RHODE ISLAND DEPARTMENT OF TRANSPORTATION

RHODE ISLAND CONTRACT NO.2019-CB-027

Bridge Group 51A - Rt 37 C-2

ADDENDUM NO. 2 Prospective bidders and all concerned are hereby notified of the following changes in the Plans, Specifications, Proposal and Distribution of Quantities for this contract. These changes shall be incorporated in the Plans, Specifications, Proposal and Distribution of Quantities, and shall become an integral part of the Contract Documents.

PROJECT SEQUENCE OF
CONSTRUCTION STAGE 1
SHEET 1

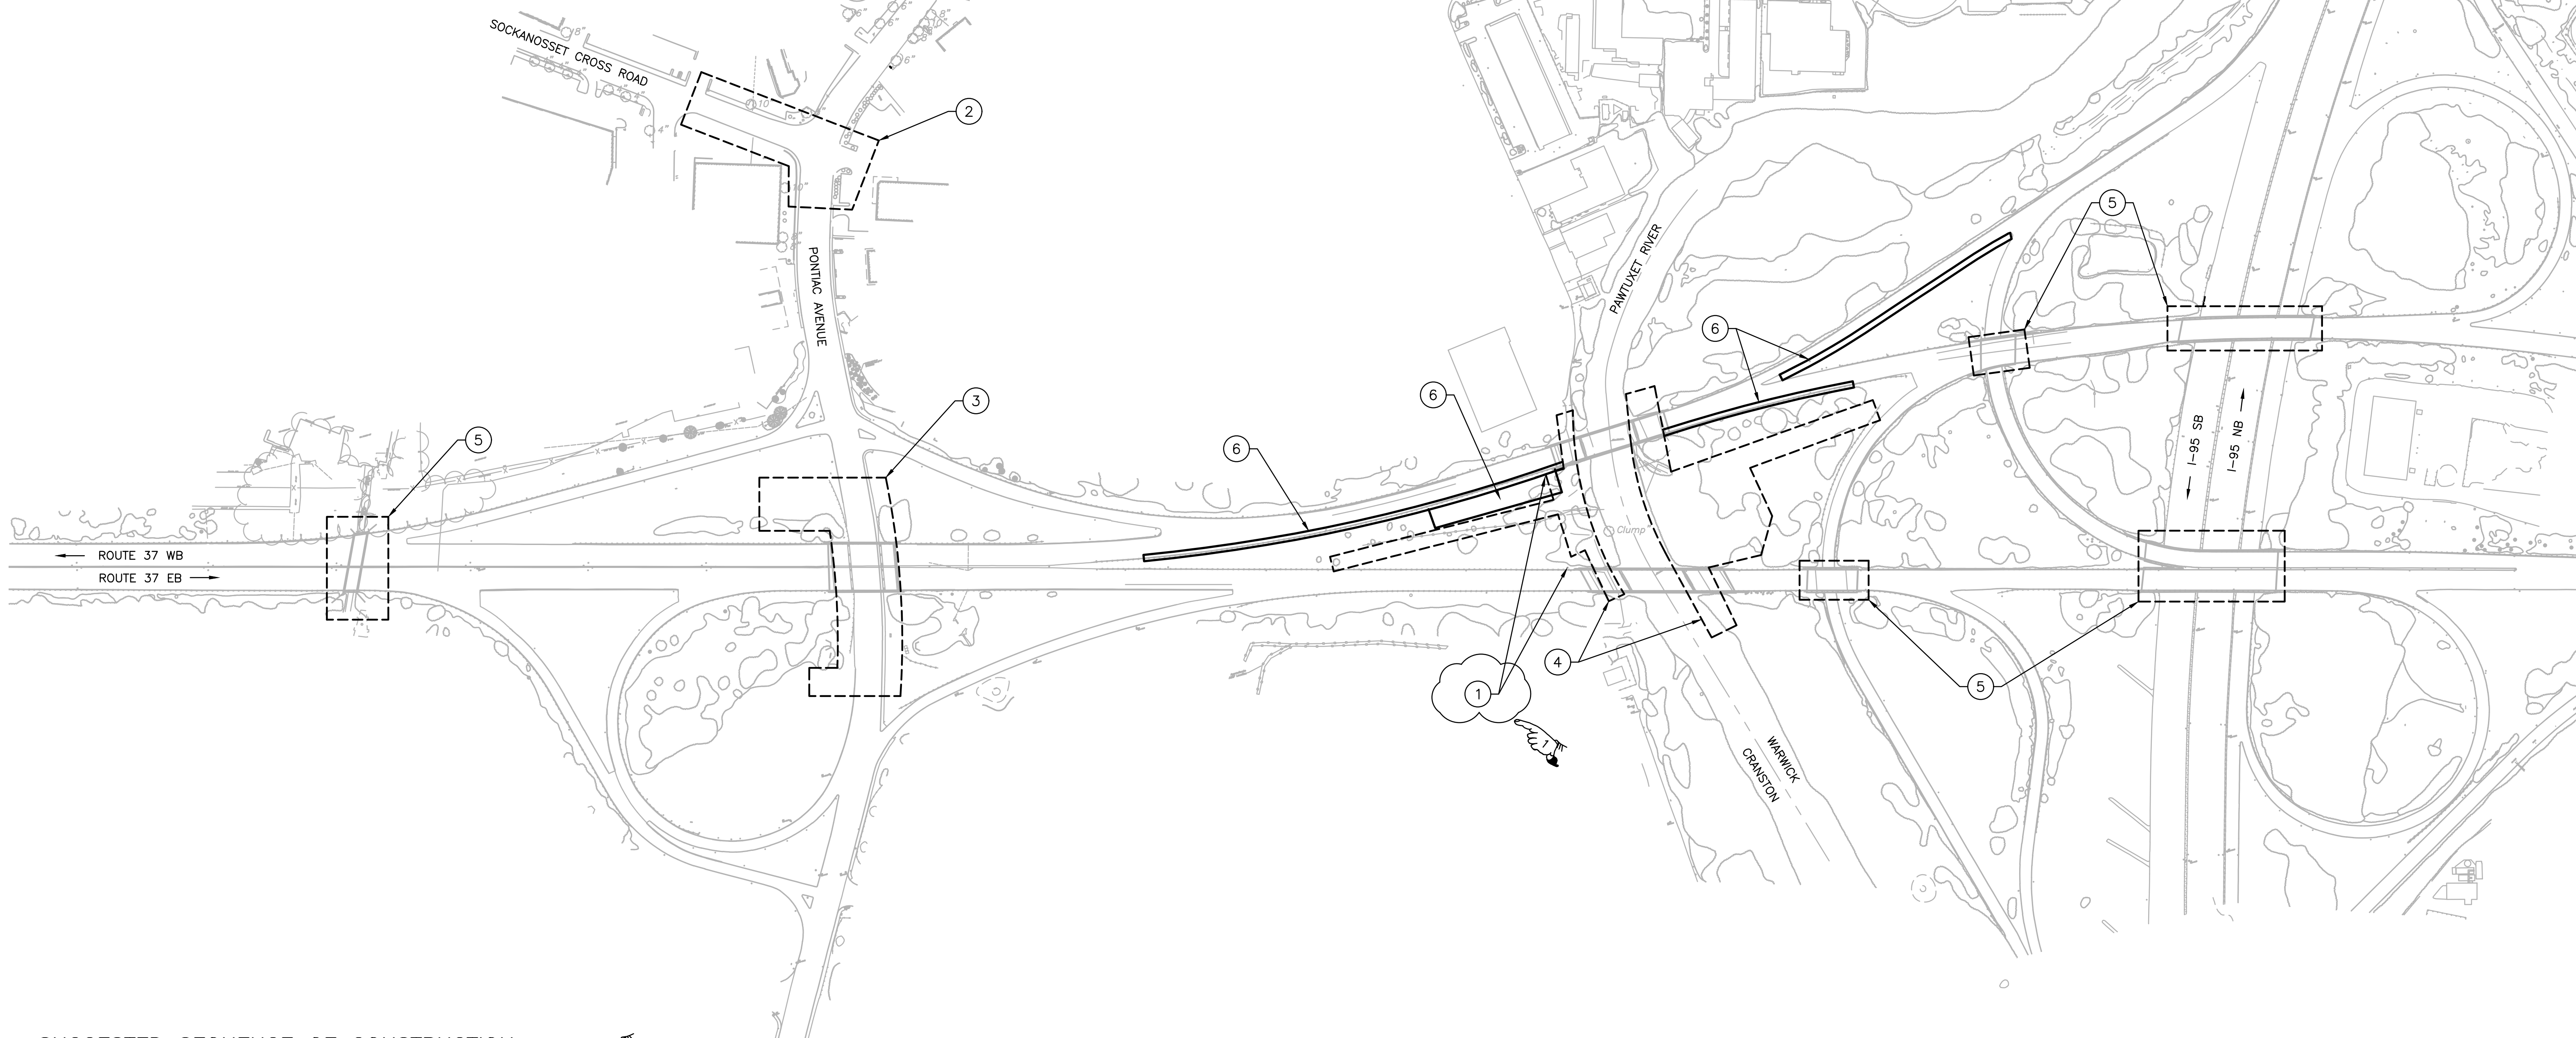
1. Delete plan sheet 7 in its entirety and replace it with Sheet 7 (R-1) attached to this Addendum No. 2. The sheet has been revised for staging note and callout.

FED. ROAD DIV. NO.	STATE	FEDERAL AID PROJECT NO.	FISCAL YEAR	SHEET NO.	TOTAL SHEETS
	RI		2019	12	80

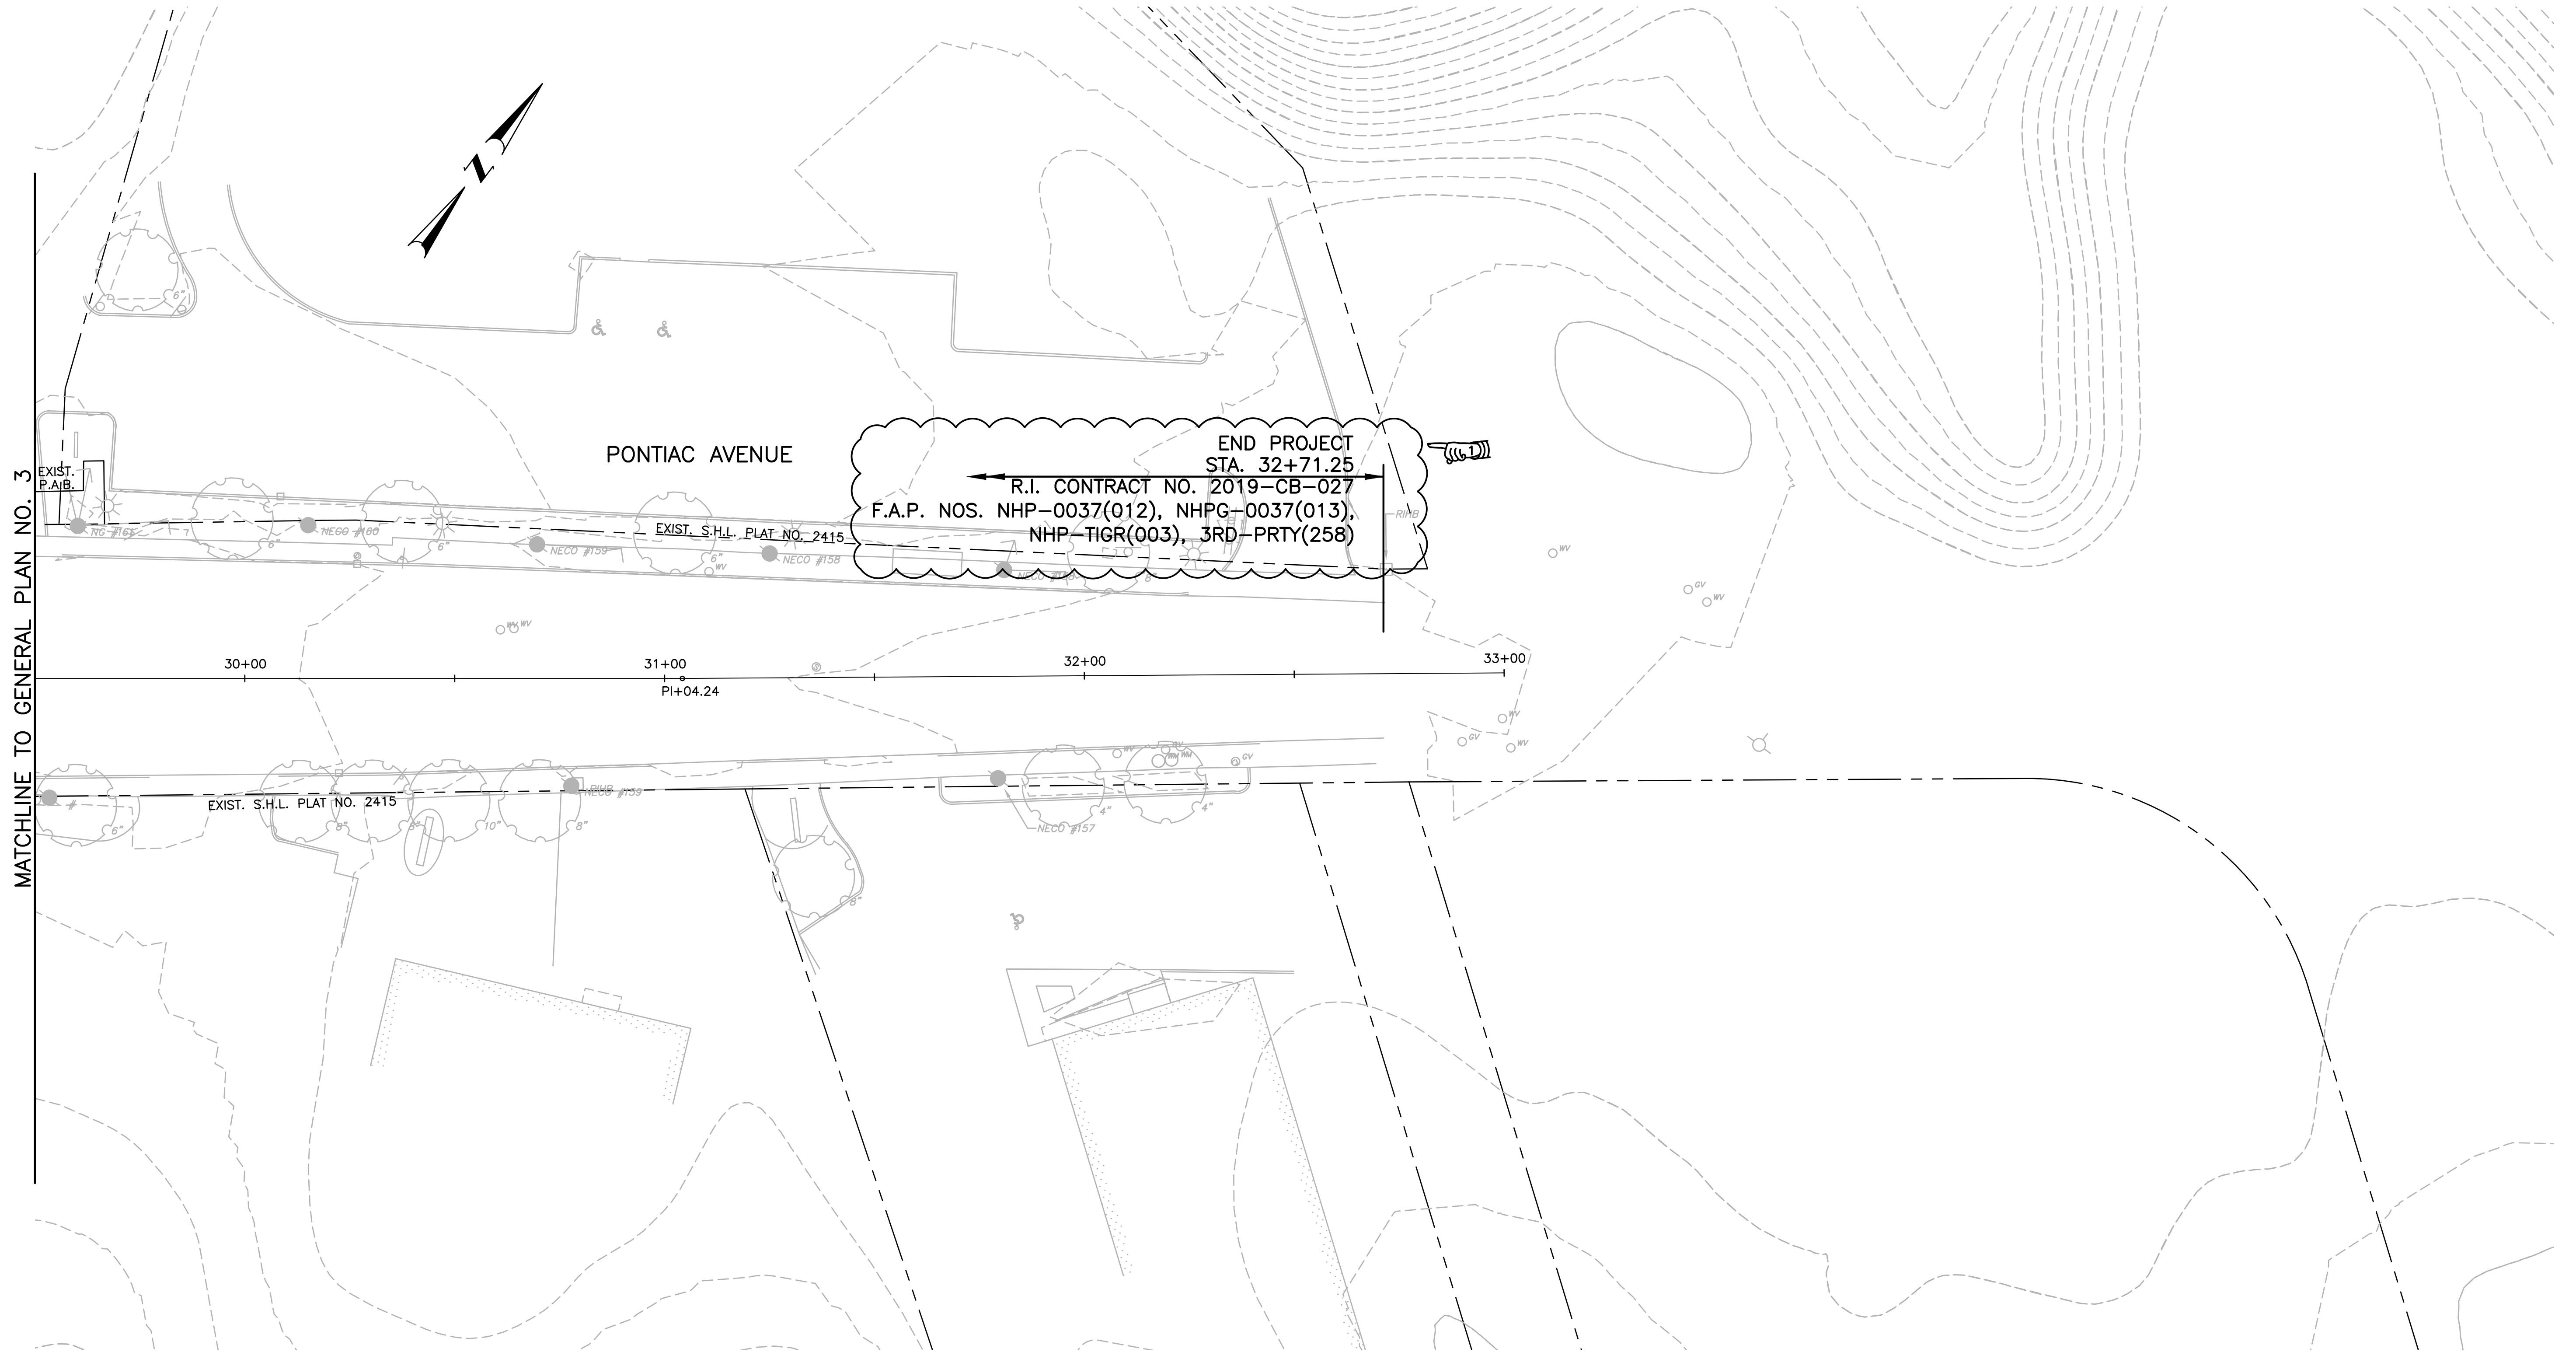
3. Delete plan sheet 10 in its entirety and replace it with Sheet 10(R-1) attached to this Addendum No. 2. Route 37 on ramp guardrail has changed.
4. Delete plan sheet 12 in its entirety and replace it with Sheet 12(R-1) attached to this Addendum No. 2. The FAP Numbers have been added to the Project Limits.

FED. ROAD DIV. NO.	STATE	FEDERAL AID PROJECT NO.	FISCAL YEAR	SHEET NO.	TOTAL SHEETS
	RI		2019	19	80

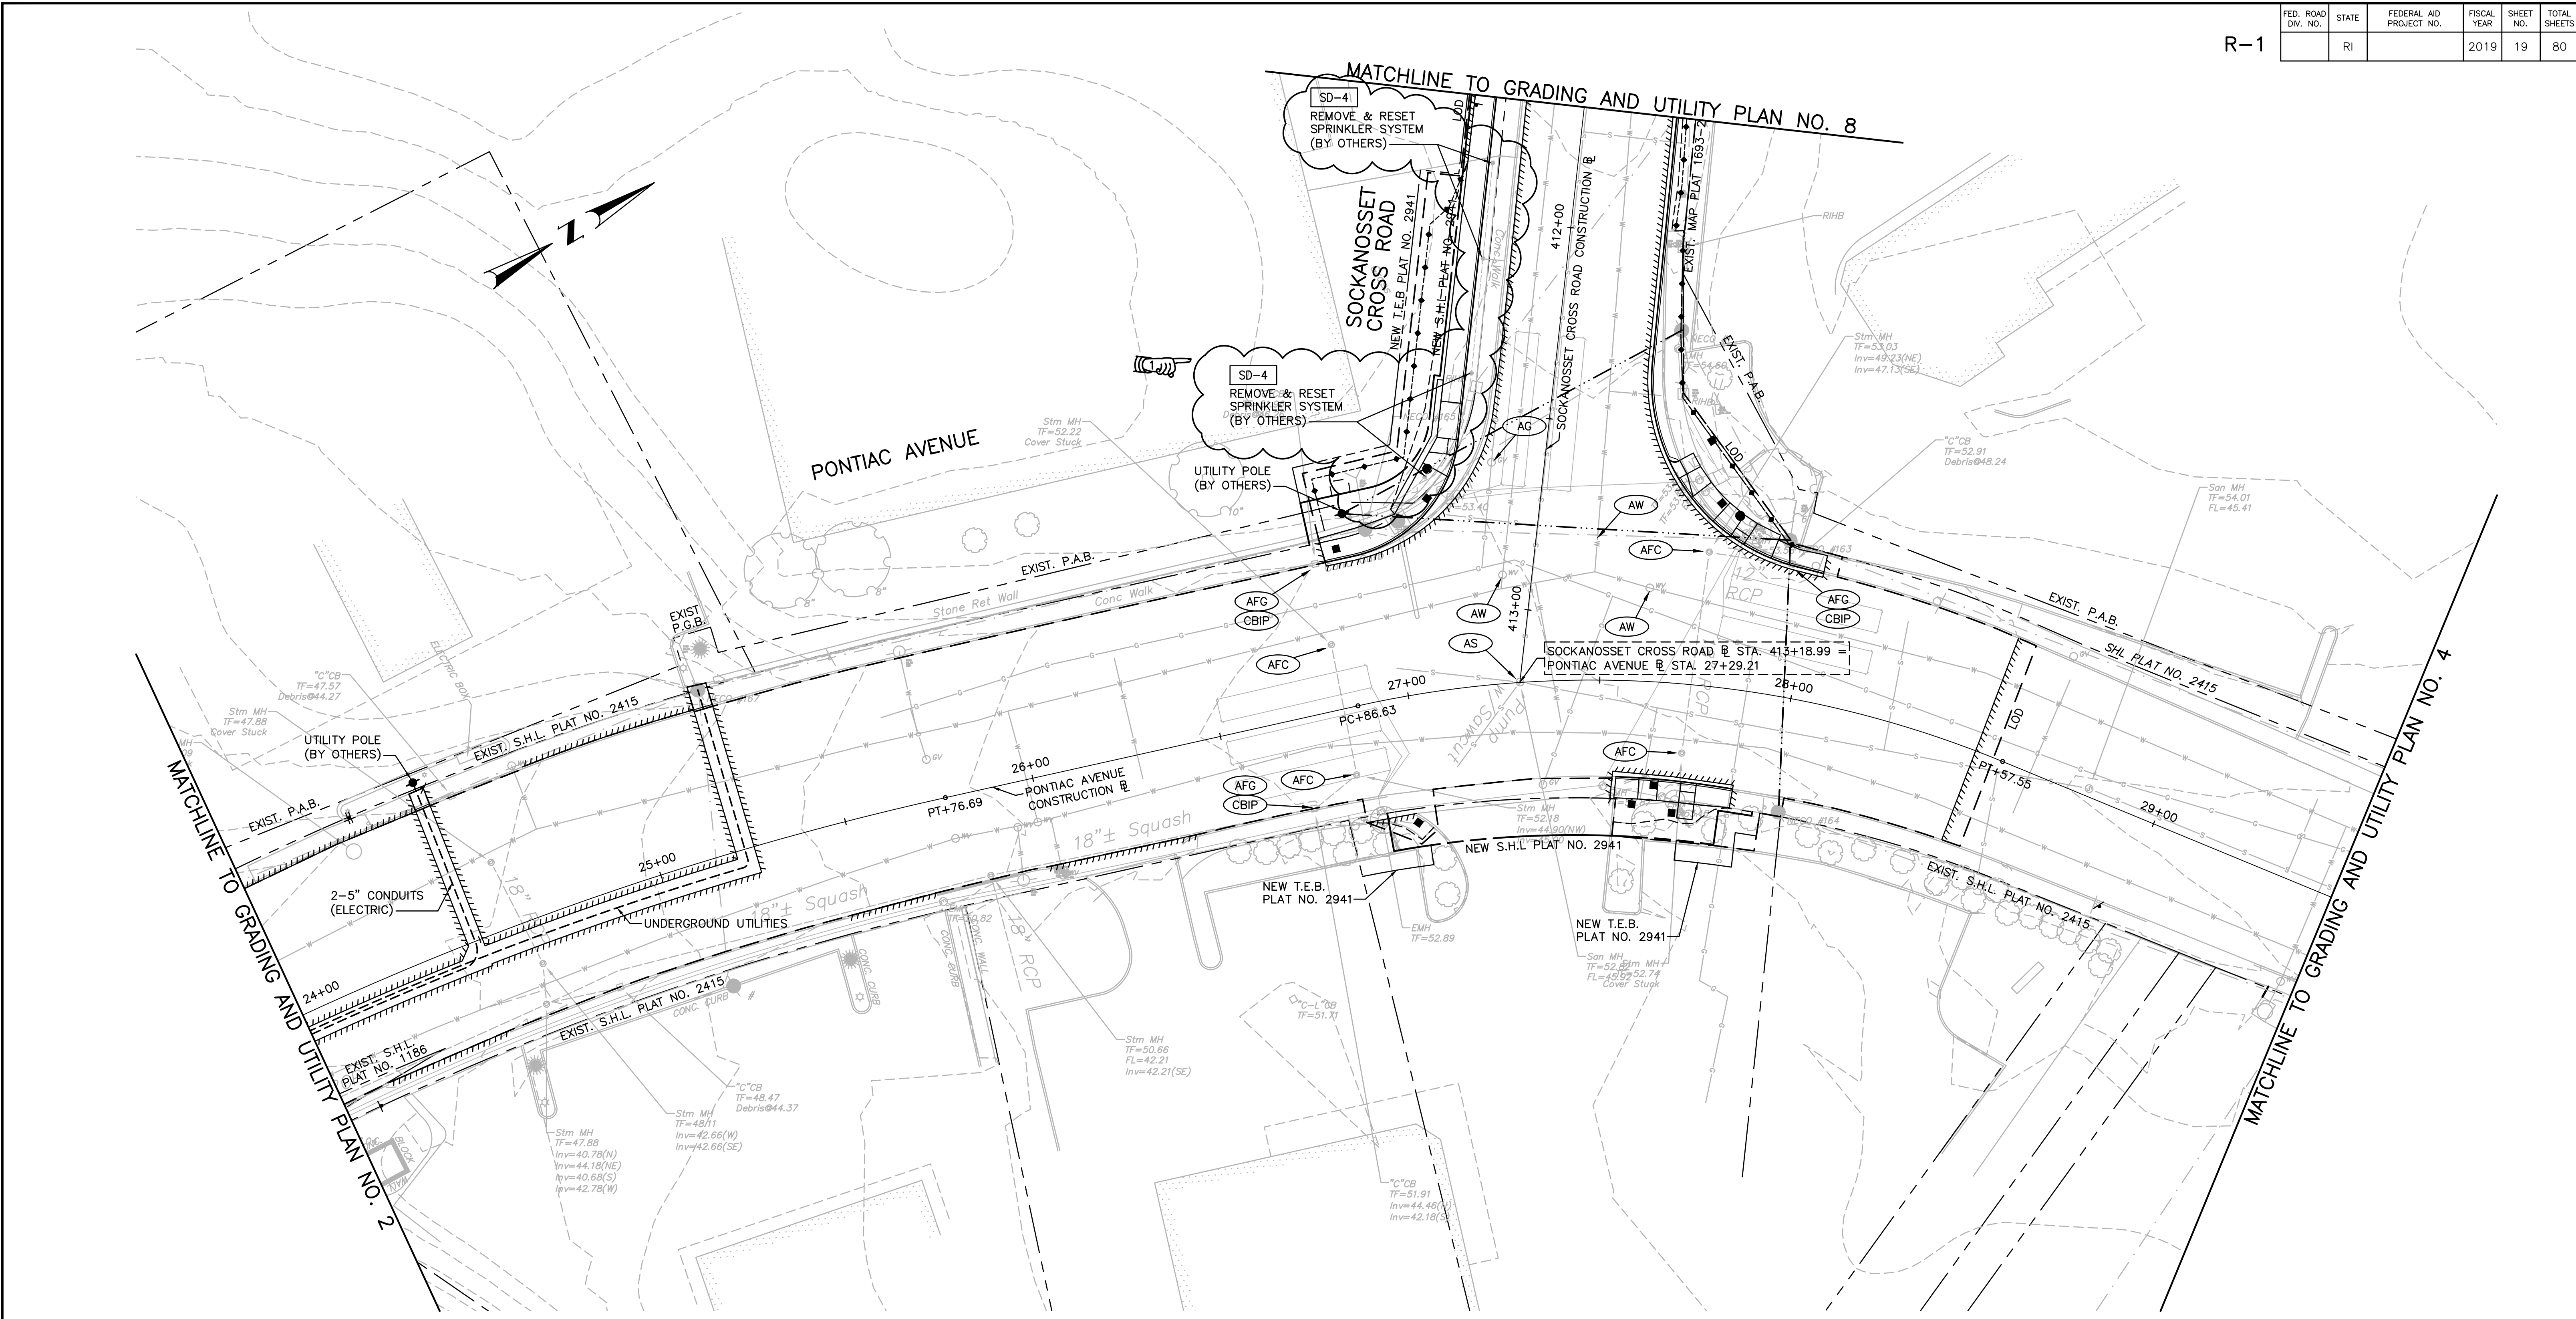
1. Delete plan sheet 19 in its entirety and replace it with Sheet 19(R-1) attached to this Addendum No. 2. The timber cribbing limits have been updated.
2. Delete plan sheet 20 in its entirety and replace it with Sheet 20(R-1) attached to this Addendum No. 2. The timber cribbing limits have been updated.
